## Product Change Notification

### PCN-PCC-7893-2022

Business Unit	Product Line Code	Type of Change	Action	Date of Issue
PCC - PCB Connectors	AAB	Product Change Notification	Notify Distributors and Field	4/7/2022

<p>MCVR 1,5/-ST-3,5/3,81 (alt-old)</p> 	<p>MCVR 1,5/-ST-3,5/3,81 (neu-new)</p> 
 <p>180° view</p>	 <p>180° view</p>
<p>MCVW 1,5/-ST-3,5/3,81 (alt-old)</p> 	<p>MCVW 1,5/-ST-3,5/3,81 (neu-new)</p> 
 <p>180° view</p>	 <p>180° view</p>

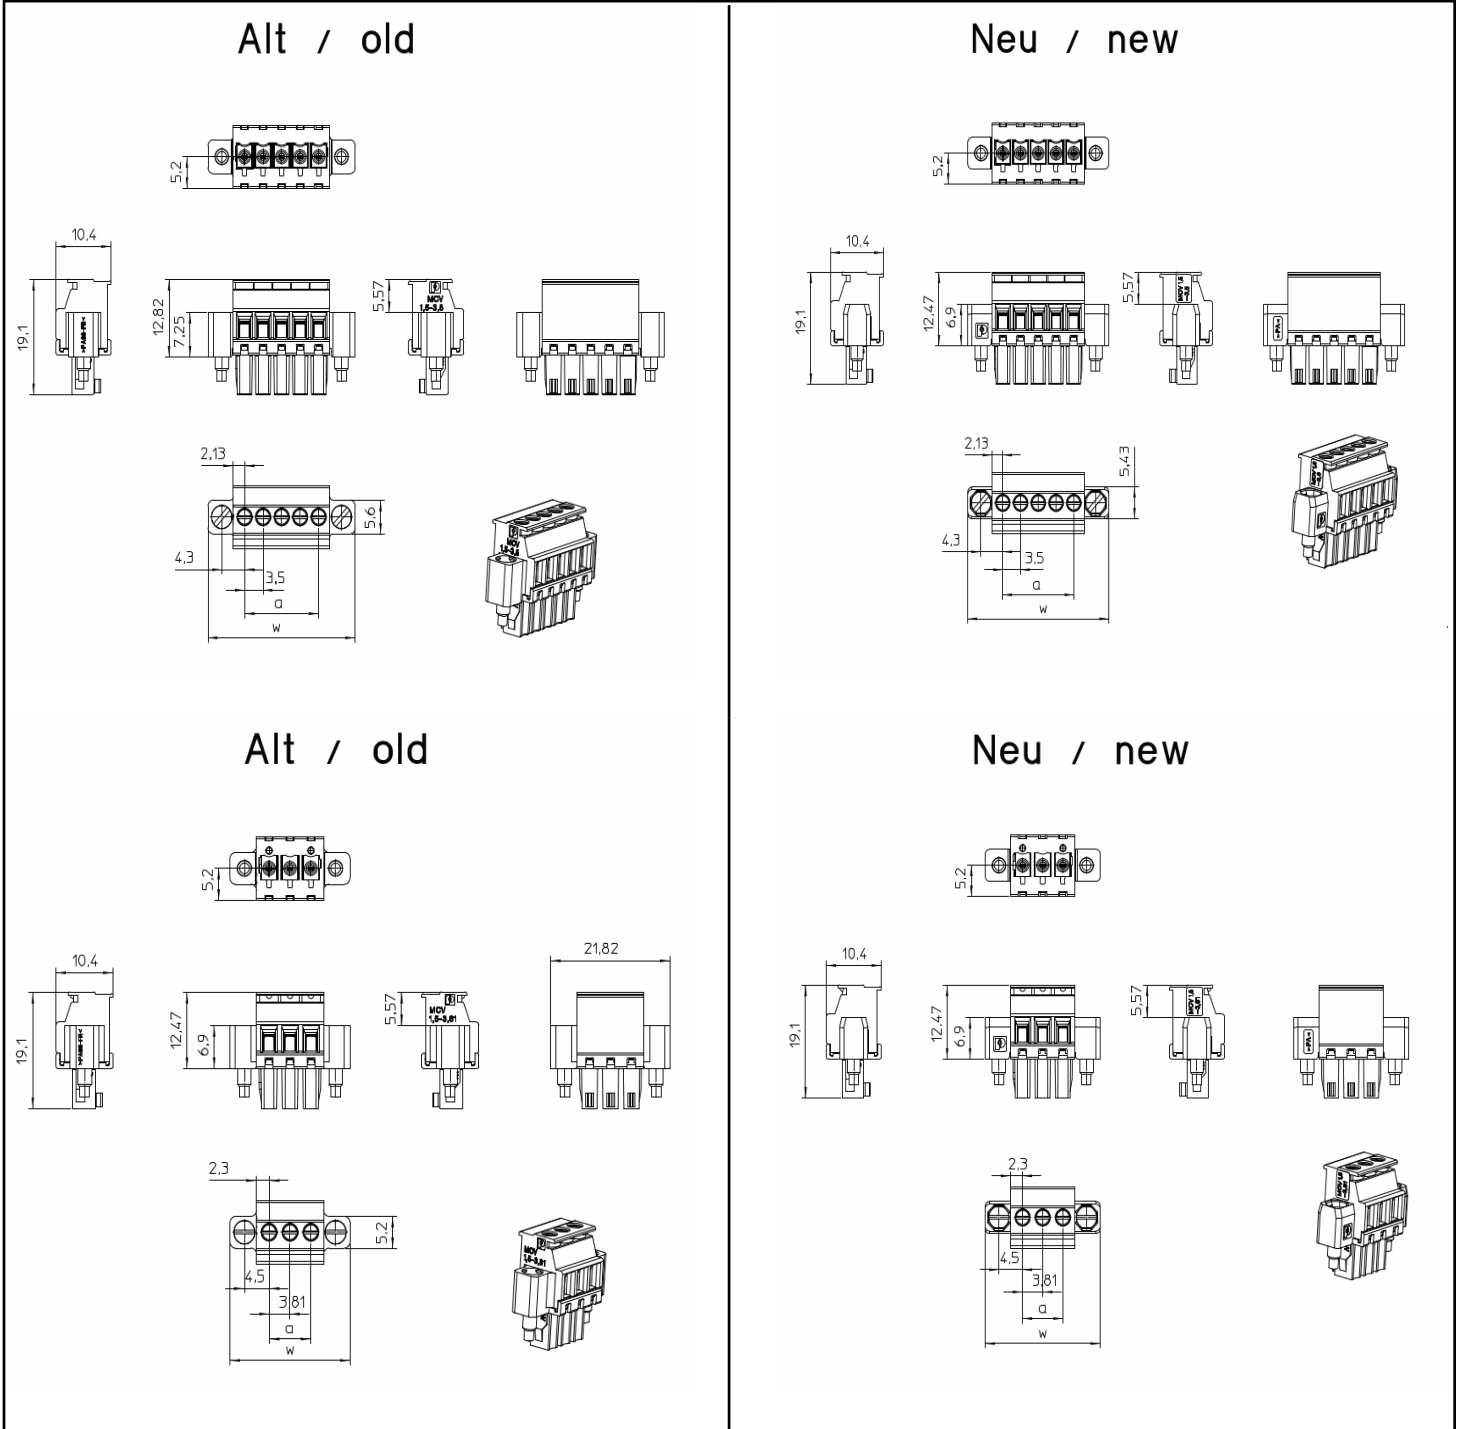
Description for Product Change Notification
As part of ongoing improvement processes, the housings and marking fields for the product families MCVR 1,5/...ST(F) and MCVW 1,5/...ST(F) are being adjusted. The external dimensions of male connectors with 3.5 mm pitch and screw flange will be reduced slightly (see drawings). The external dimensions of male connectors with 3.81 mm pitch remain unchanged. In addition, the marking fields will be updated for all versions (see drawings). The PCB layout, approvals, and technical data remain unchanged.
